A1 in Northumberland: Morpeth to Ellingham

Scheme Number: TR010059

7.22 Applicant's Response to Deadline 4 Submissions

Applicant's Response to Deadline 4 Submissions

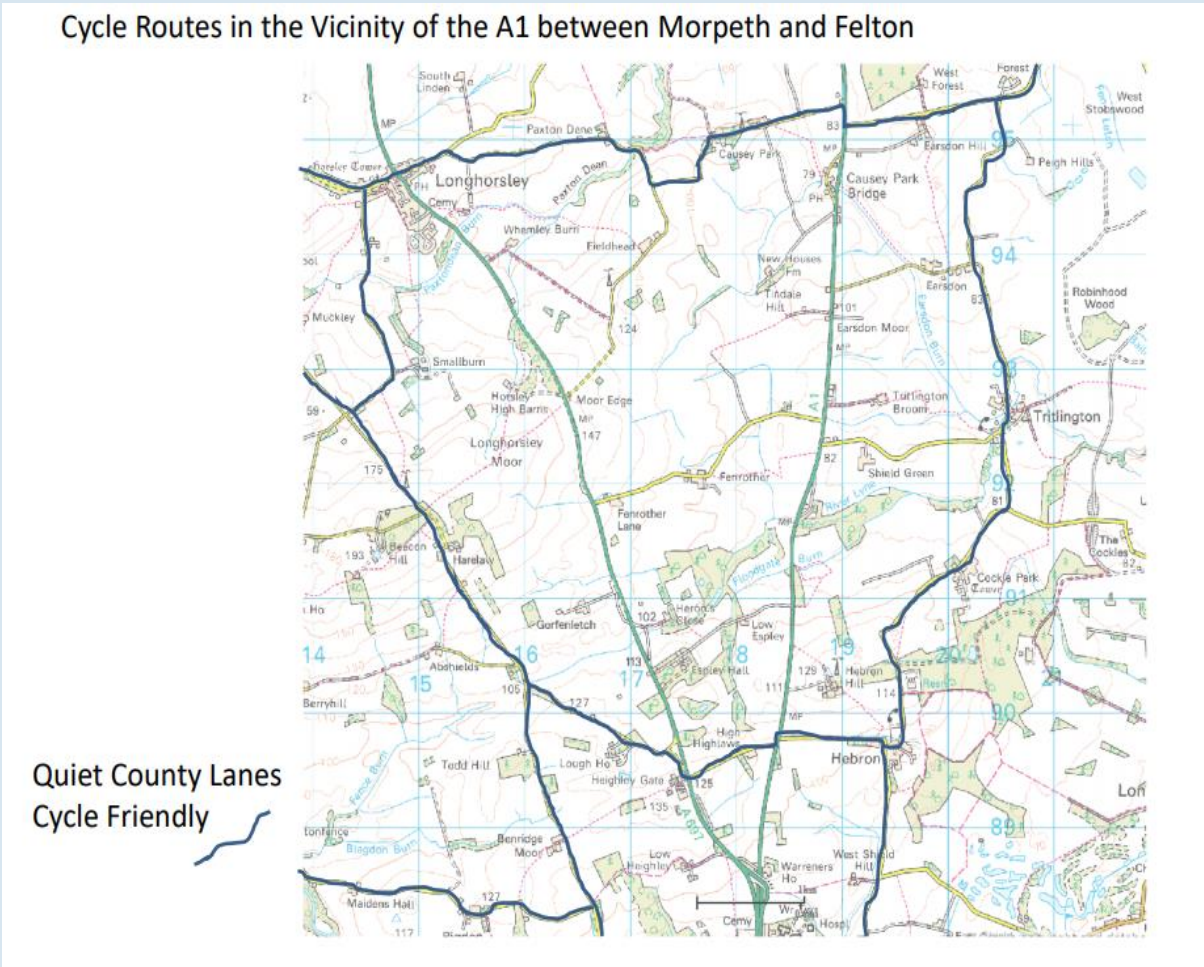
Ref. No.	Response:	Applicant's Response:																																								
7	<p>Table 36.1 - Annual Average daily flow (Source: Highways England's publicly available database. Counter located at Burgham Park - site location 9755/1 and 9755/2)</p> <table><tr><th>Year</th><th>Northbound</th><th>Southbound</th><th>2-way</th></tr><tr><td>2019</td><td>9,836</td><td>10,005</td><td>19,841</td></tr><tr><td>2020*</td><td>7,587</td><td>7,755</td><td>15,342</td></tr></table> <p>*The 2020 figures show the effects of COVID lockdown on traffic levels.</p>	Year	Northbound	Southbound	2-way	2019	9,836	10,005	19,841	2020*	7,587	7,755	15,342	<p>1. The Applicant confirms that the figures shown in Table 36.1 provided by NCC are consistent with the published Highways England WebTRIS data from the Burgham Park sites (references 9755/1 and 9755/2).</p>																												
Year	Northbound	Southbound	2-way

2019	9,836	10,005	19,841																																							
2020*	7,587	7,755	15,342																																							
8	<p>The forecast traffic flows after de-trunking are shown in Table 36.2.</p> <p>Table 36.2 – Forecast Traffic Flows on De-Trunked A1 within Part A (Source: Traffic flows from SATURN model of scheme as supplied by WSP)</p> <table><tr><th>Year</th><th>Northbound</th><th>Southbound</th><th>2-way</th></tr><tr><td>2019</td><td>9,836</td><td>10,005</td><td>19,841</td></tr><tr><td>2020*</td><td>7,587</td><td>7,755</td><td>15,342</td></tr></table> <p>*Figures based upon Environmental Statement version of the Model as advised by WSP.</p> <p>Analysis of these flows indicate an 83% reduction on the 2020 figures and 87% reduction on the 2019 figures on the busiest section (Fenrother to Earsdon). The reduction in traffic flows will lead to an increase in traffic speeds.</p>	Year	Northbound	Southbound	2-way	2019	9,836	10,005	19,841	2020*	7,587	7,755	15,342	<p>1. The figures provided in Table 36.2 are identical to those in Figure 36.1 and assumes that these have been provided in error. The Applicant emailed the Highways Officer at NCC to obtain the correct information, which were supplied by email on 24th March 2021 and are shown below:</p> <p>Table 36.2 – Forecast Traffic Flows on De-Trunked A1 within Part A (Source: Traffic flows from SATURN model of scheme as supplied by WSP direct to NCC)</p> <table><tr><th>Section</th><th>AM Peak (2-way)</th><th>PM Peak (2-way)</th><th>Annual Average Daily Traffic (AADT)*</th></tr><tr><td>South of Fenrother</td><td></td><td></td><td>152</td></tr><tr><td>Fenrother to Earsdon</td><td>192</td><td>213</td><td>2,525</td></tr><tr><td>Earsdon to Causey Park</td><td>168</td><td>201</td><td>2,436</td></tr><tr><td>Causey Park to Eshott</td><td>50</td><td>75</td><td>1,241</td></tr><tr><td>Eshott to Burgham Park</td><td>21</td><td>42</td><td>547</td></tr><tr><td>Burgham Park to West Moor</td><td>31</td><td>58</td><td>723</td></tr></table> <p>2. The Applicant agrees that the forecast AADT flows on the section from Fenrother to Earsden indicate an 83% reduction compared with the 2020 figures and an 87% reduction compared with the 2019 figures in Table 36.1.</p> <p>3. Vehicle speeds are influenced by many factors including speed limits, geometry, visibility, levels of traffic, street activity, frequency of junctions and PMAs, lining and signage, location of speed cameras and individual behaviour. The Applicant is not proposing to change the speed limit on the de-trunked section as part of the Scheme but notes that NCC may choose to do so and it could propose such a provision in the DCO if sought by NCC (although its position is that this is not needed). The Applicant</p>	Section	AM Peak (2-way)	PM Peak (2-way)	Annual Average Daily Traffic (AADT)*	South of Fenrother			152	Fenrother to Earsdon	192	213	2,525	Earsdon to Causey Park	168	201	2,436	Causey Park to Eshott	50	75	1,241	Eshott to Burgham Park	21	42	547	Burgham Park to West Moor	31	58	723

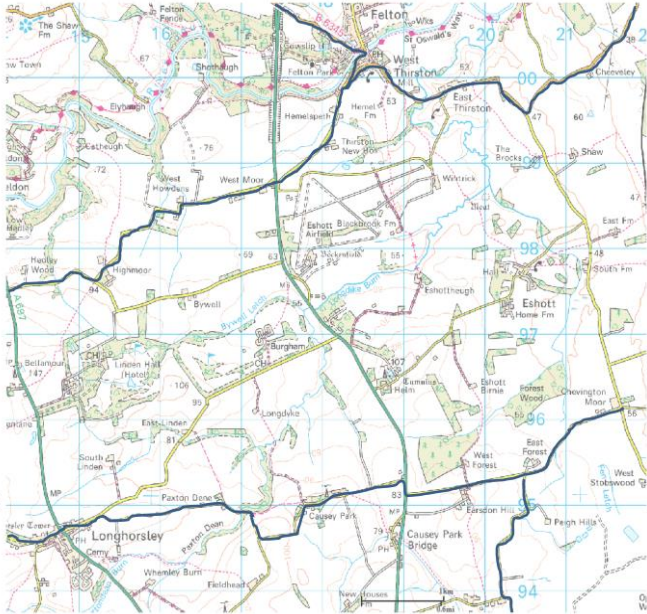
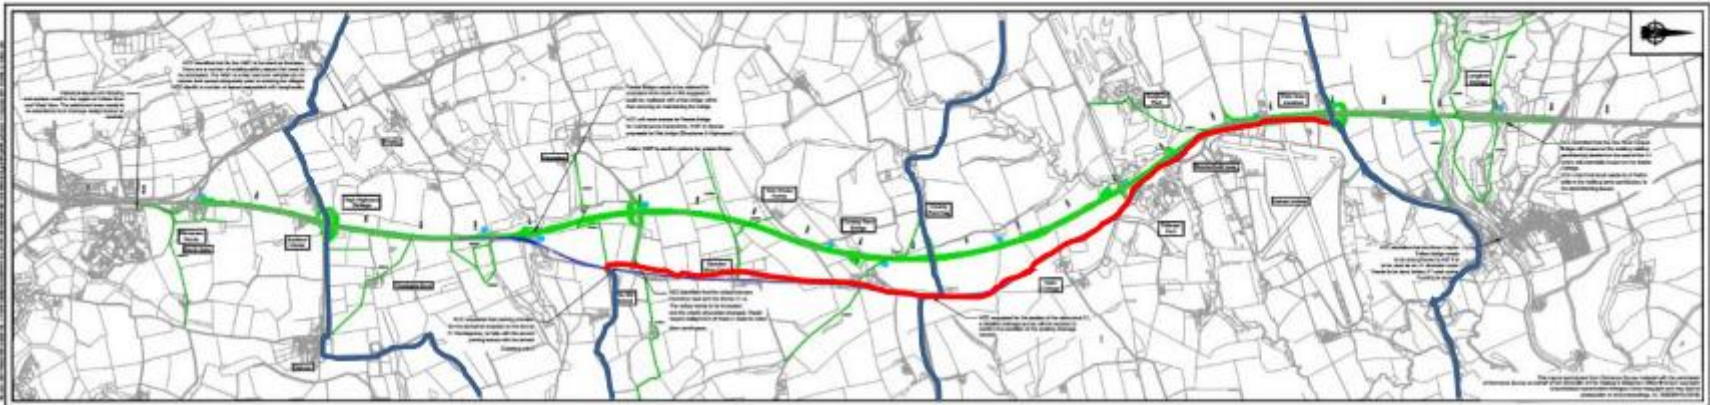
Ref. No.	Response:	Applicant's Response:
25	<p>In relation to the Designated Funding details as discussed in the Hearing Sessions we can confirm attendance at a meeting with the applicant to discuss this on 18th March where we will continue to engage with the applicant to provide means of securing non-motorised transport connectivity as part of the scheme and we will actively engage with the applicant in this process.</p>	<p>1. The Applicant will continue to work with NCC to build the best-case possible to bid for and secure alternative funding although the Applicant has been clear that this funding is not guaranteed. It is noted that the delivery of any designated funds scheme sits outside of the DCO application and such works are not required to mitigate the impacts of the proposed Scheme.</p>
26	<p>Cycle Routes in the Vicinity of the A1 between Morpeth and Felton</p>  <p>Quiet County Lanes Cycle Friendly</p>	<p>1. N/A</p>

Ref. No.	Response:	Applicant's Response:
27	<div></div> <p>Quiet Country Lanes Cycle Friendly</p>	1. N/A
28	<div></div> <p> Cycle Links Crossing or Joining A1</p> <p> Section of De-Trunked A1 and New Link Road to West Moor Junction to be cycle friendly</p>
